DART SERVICE INSTRUCTION

TO AMEND INSTALLATION INSTRUCTIONS D350-607-3 Rev.D,
INSTALLATION INSTRUCTIONS D350-607-4 Rev. C AND
INSTRUCTIONS FOR CONTINUED AIRWORTHINESS ICA-D350-607 REV. 6
REF TCCA STC: SH94-14
REF FAA STC: SR00213NY
REF EASA STC: EASA.10016996
REF BRAZILIAN STC: 2007S03-03/-04/-05/-06

A	NEW ISSUE	AJS	14.05.16
REV.	DESCRIPTION	BY	DATE
DESIGN	AJS	DART AEROSPACE LTD HAWKESBURY, ONTARIO, CANADA	
DRAWN	AJS		
CHECKED	N/A	DRAWING NO.	REV. A
MFG. APPR.	N/A	DSI 9699	SHEET 1 OF 2
APPROVED	N/A	TITLE	SCALE
DE APPR.	N/A	LUG REPLACEMENT	NTS
DATE	14.05.16	COPYRIGHT © 2014 BY DART AEROSPACE LTD THIS DOCUMENT IS PRIVATE AND CONFIDENTIAL AND IS SUPPLIED ON THE EXPRESS CONDITION THAT IT IS NOT TO BE USED FOR ANY PURPOSE OR COPIED OR COMMUNICATED TO ANY OTHER PERSON WITHOUT WRITTEN PERMISSION FROM DART AEROSPACE LTD.

FIGURE 1: INSTALLATION OF D4775-041 FWD STRUT

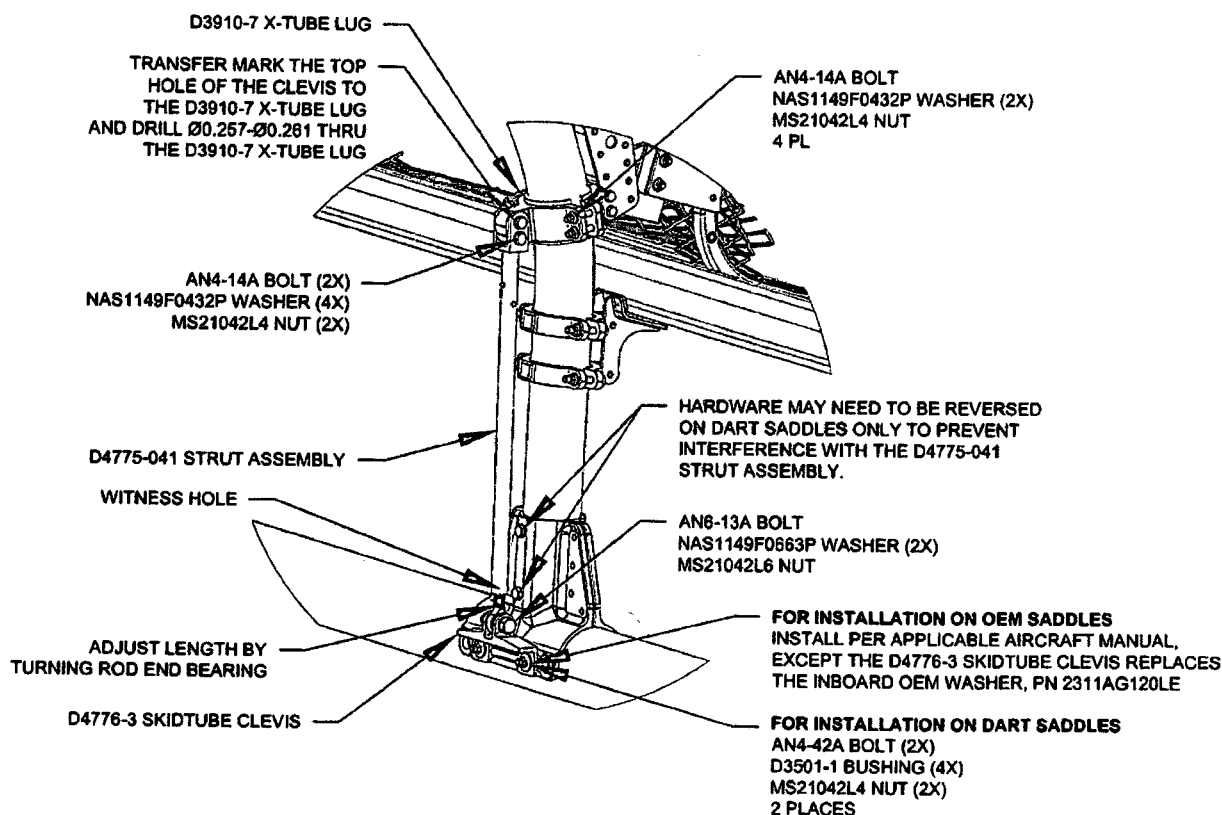
Modify the quantities for D3910-5 and add D3910-7 as follows:

- 3.1 Substitute the Forward Lower D3910-5 X-Tube Lug with the D3910-7 X-Tube Lug as shown in Figure 1.
- 3.2 Install the forward D4775-041 Strut Assembly. Transfer mark from the upper hole on the clevis of the D4775-041 Strut Assembly to the D3910-7 X-tube Lug and drill thru the lug $\varnothing 0.257$ - $\varnothing 0.261$ as shown in Figure 1. Touch up chemical conversion coating per MIL-DTL-5541. Check the witness holes located at the bottom end of the D4775-041 Strut Assemblies to ensure that the thread from the rod end extends past the witness hole.
Torque MS21042L4/-4 nuts to 50-70 in-lbs (5.7-7.9 N-m). Torque MS21042L6/-6 nuts to 160-190 in-lbs (18.1-21.5 N-m).
- 3.3 Complete the installation in accordance with Installation Instructions D350-607-3 Rev. D or D350-607-4 Rev. C.
